SUBJECT: Administrative Approval for Petition No. 99-45 by Marriott International, Inc. Tax parcel 047-141-12.

FOR PUBLIC HEARING - REZONING PETITION - TECHNICAL DATA SHEET - PETITION # 99 - 45

FOR PUBLIC HEARING - REZONING PETITION - SCHEMATIC SITE PLAN - PETITION # 99 - 45

DATE: July 3, 2000  
TO: Robert Brandon, Zoning Administrator  
FROM: Martin Cramton, Director of Planning  
SUBJECT: Administrative approval for Marriott International, Inc - Romano's Macaroni Grill (rezoning file 99-45).

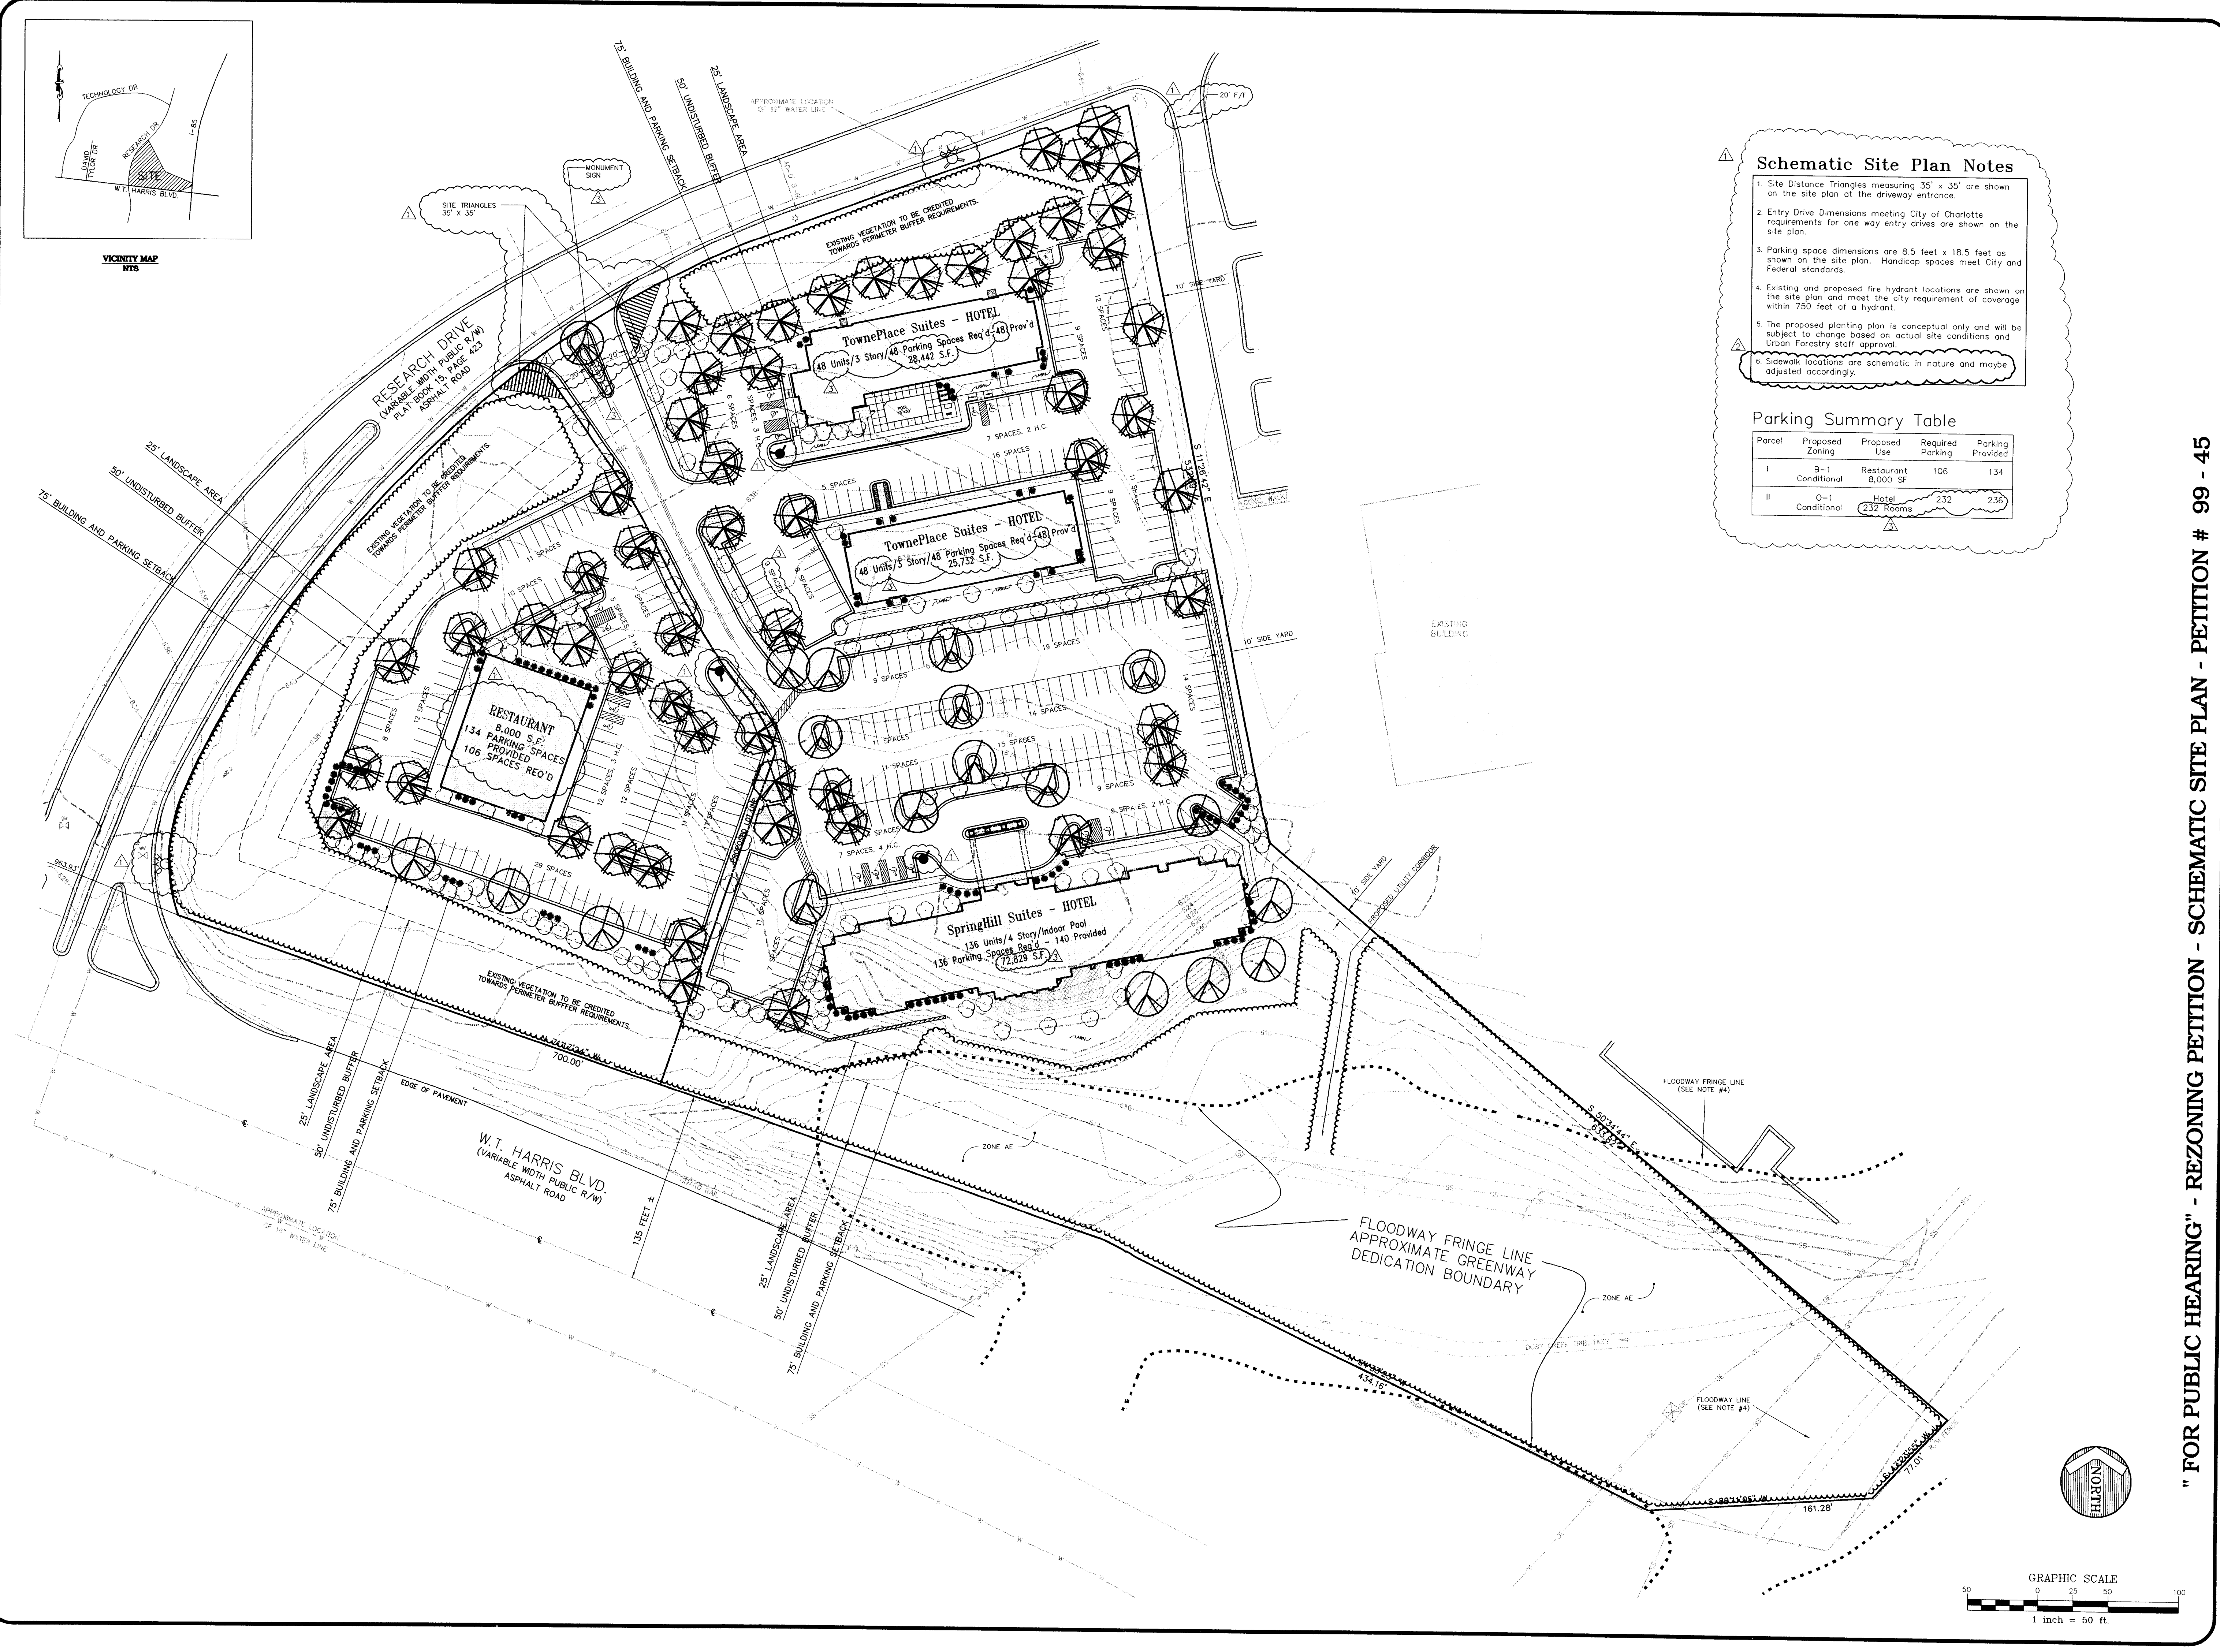
Attached is a copy of the revised plan for the above rezoning petition. The plan has been revised to allow one additional hotel room, the option to remove certain trees within the buffer and authorization to place a monument sign within a portion of the undisturbed buffer area and landscape area along Research Drive. These changes will not increase the total square footage from the present approval plan. Since these changes do not alter the intent of the development and are minor, I am administratively approving this revised plan. Please use this revised plan when evaluating request for building permits and certificates of occupancy.

**LANDSCAPING PLAN**  
CHARLOTTE NORTH CAROLINA  
Drawn JDC FX Job 99-036 Drawing 1

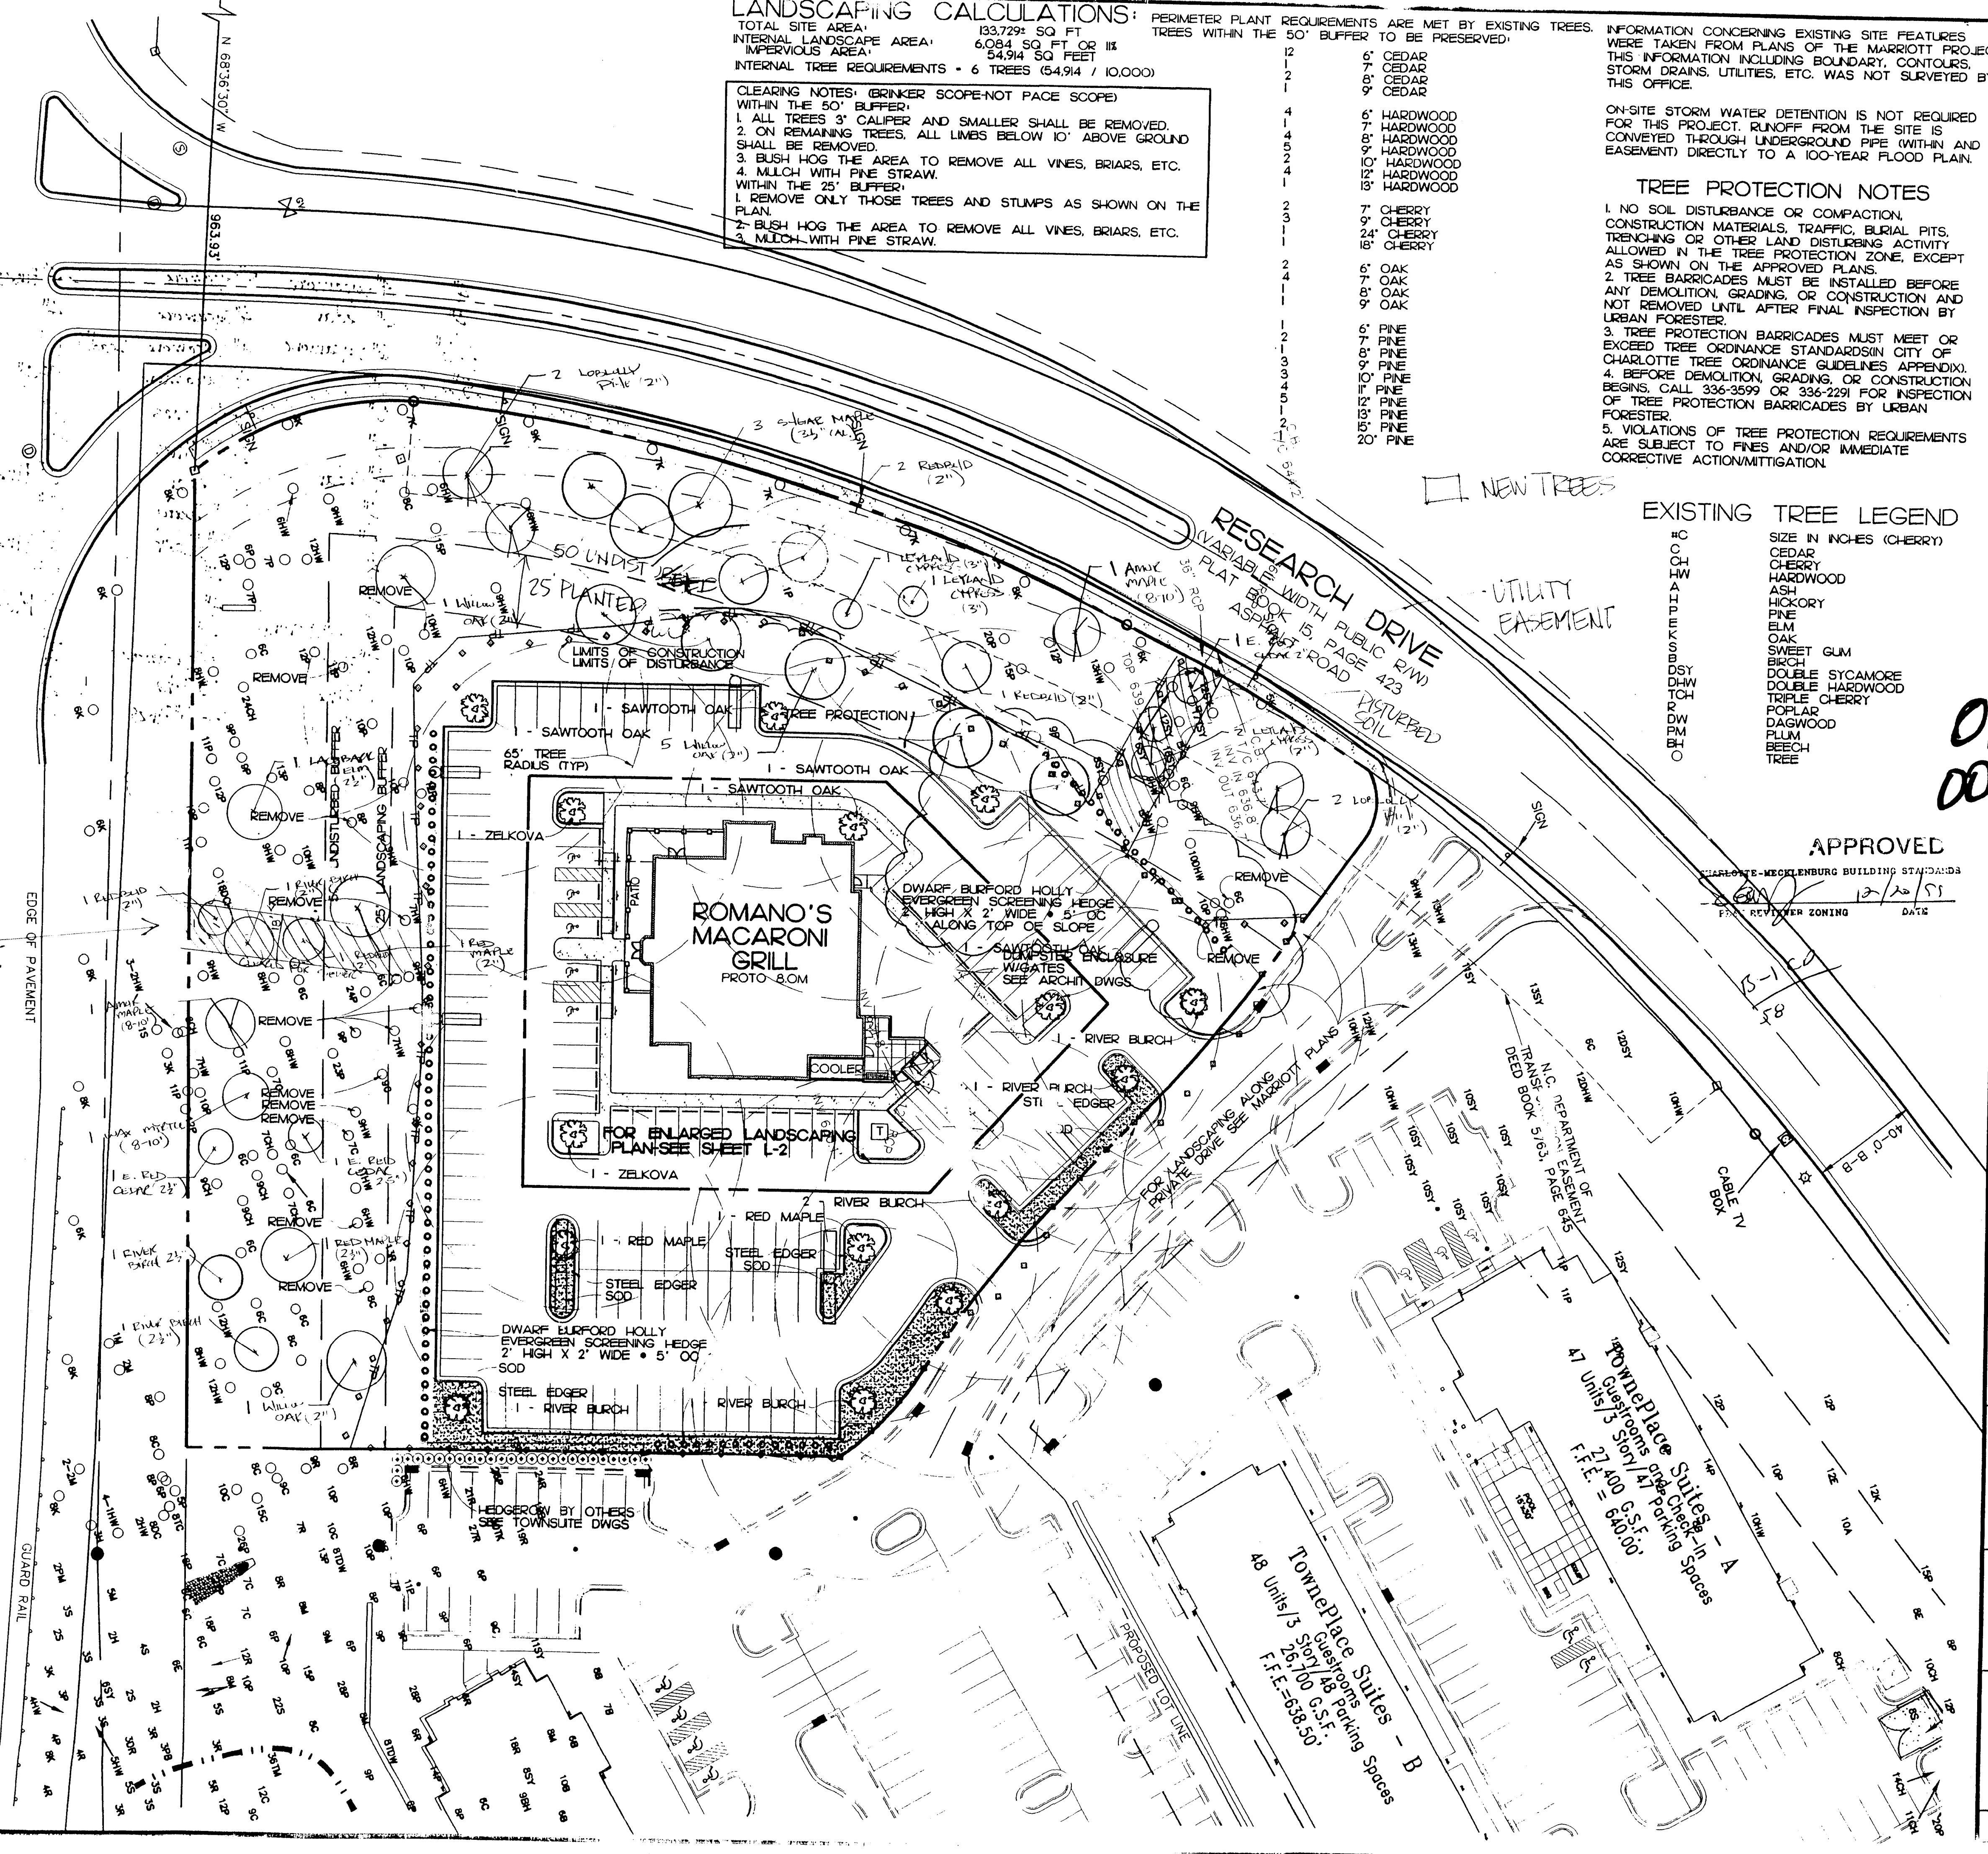
Attached are the revised drawings for Romano's Macaroni Grill. The 1999 rezoning (99-45) note #2 indicated that trees with a caliper of 3" or less may be removed from all buffer areas. The attached plan has been revised to indicate the trees within the 50' undisturbed buffer that will be planted. These trees are to replace the trees within this buffer that have inadvertently been removed. In addition, this plan indicates the trees required to be placed within the 25' foot landscape area as depicted on the Schematic Site Plan and the trees, which are to be installed within the disturbed utility easements. Since these changes are minor, I am administratively approving this revised plan. Please use this revised plan when evaluating requests for building permits and certificates of occupancy.
